**Re: Response to DPHI Key Issues 6 & 7
Chatswood Dive Site – Build -to-Rent (SSD -100006957)
RWDI Project #2512617**

RWDI has been engaged to respond to the Department of Planning, Housing and Infrastructure (DPHI) request for further information regarding pedestrian-level wind impacts associated with the proposed Build-to-Rent (BTR) development at the Chatswood Dive Site.

Image 1: Pedestrian Wind Comfort Conditions without the inclusion of Landscape

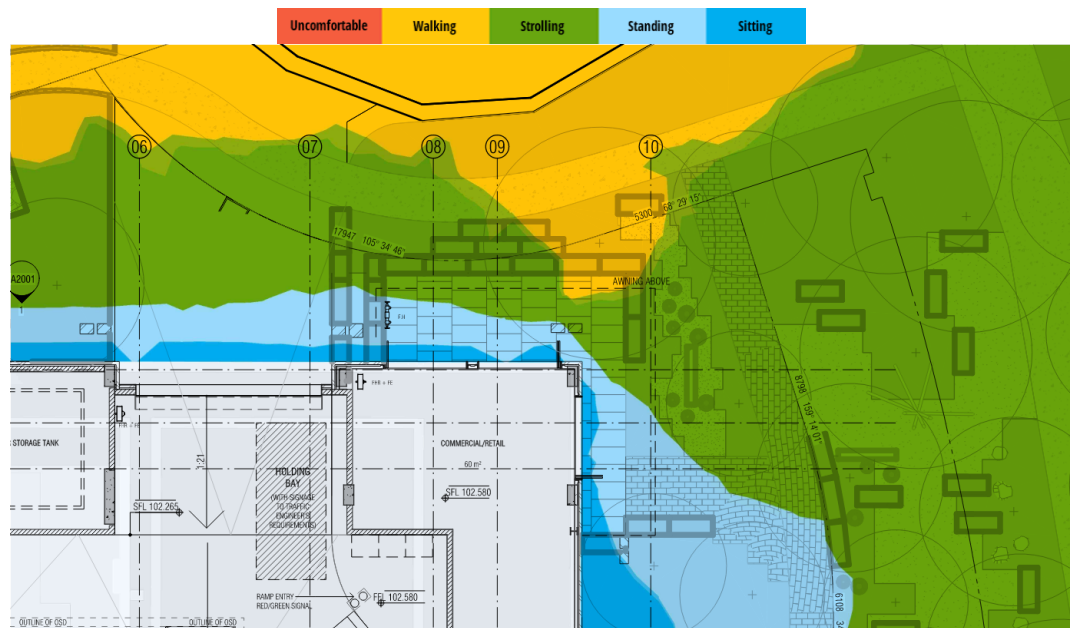
The wind comfort levels at the north-east corner without the inclusion of landscape are shown in Image 1. Wind conditions are expected to range from sitting to standing use within most of the retail spill-out zone and increase to strolling and walking use conditions moving away from the corner and within the play area.

It is noted that the wind impacts within the play area are considered appropriate for the intended use of the space without mitigation. However, conditions within the seating areas are generally above the target sitting criterion. Further analysis of wind flows indicates that wind impacts around the corner are governed by surface-level winds from the west flowing along Nelson Street and southerly winds channelling through the play-area.

Image 2: Pedestrian Wind Comfort Conditions with BTS Component and Landscape

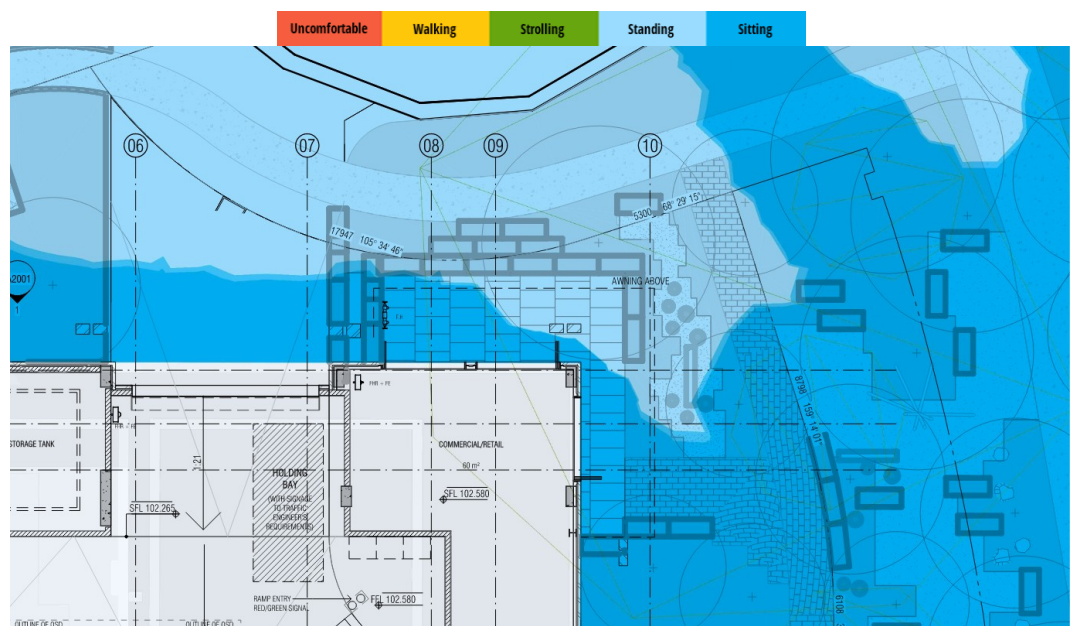
Image 2 provides the wind comfort map with the inclusion of landscape and the Build-to-Sell (BTS) component of the Chatswood Dive Site. It is noted that the landscaping modelled in the wind assessment included fully mature trees confirmed at the time of the assessment and excluded lower-level vegetation (e.g. shrubs) and subsequent design updates.

With these inclusions, the overall wind environment is predicted to improve substantially compared to the baseline scenario with all areas noted to be suitable for sitting to standing use.

Image 3: Proposed Landscape Design (Source: Oculus)

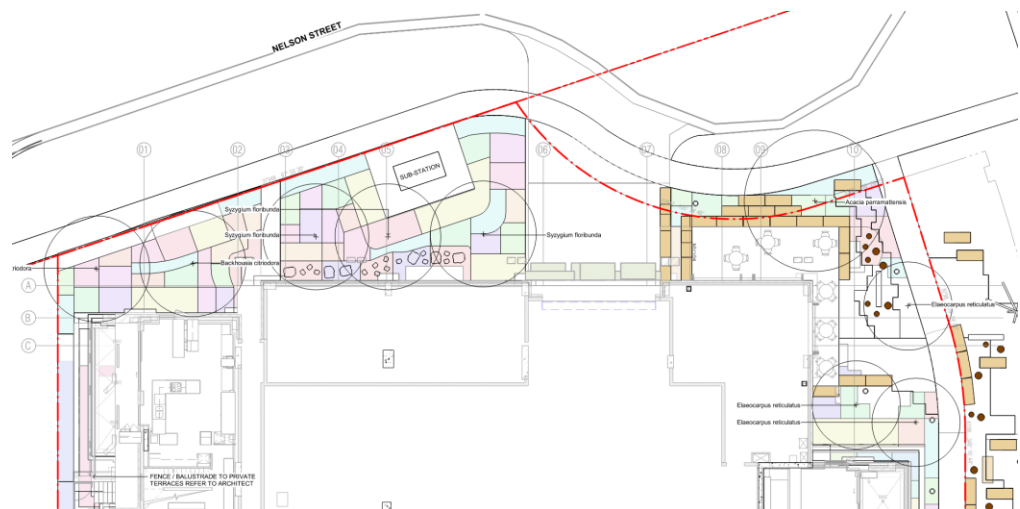
While additional wind mitigation measures are generally not required due to the improved wind environment, slightly elevated winds at the corner of the retail spill-out zone (approaching standing use) have been considered further through a review of the updated Day 1 landscape design.

- **Additional Vegetation along Nelson Street:** The newly proposed *Syzygium Floribundum* trees (approximately 3.5 m height and 2.5 m width) located west of the site were not included in the original simulations. These trees in combination with the adjacent substation are expected to reduce the westerly wind component impacting the corner.
- **Corner Planting:** The local trees around the corner, including the *Acacia Parramattensis* and *Elaeocarpus Reticulatus* (both with heights of up to 3.5 – 4m and widths of 2 – 3 m), are likely to further mitigate wind movement around the corner.

Therefore, the review of proposed Day 1 landscape design is expected to further improve the local wind conditions around the north-east corner of the development and is expected to enable the space to achieve the target criteria for both the spill-over zone and the play-area.
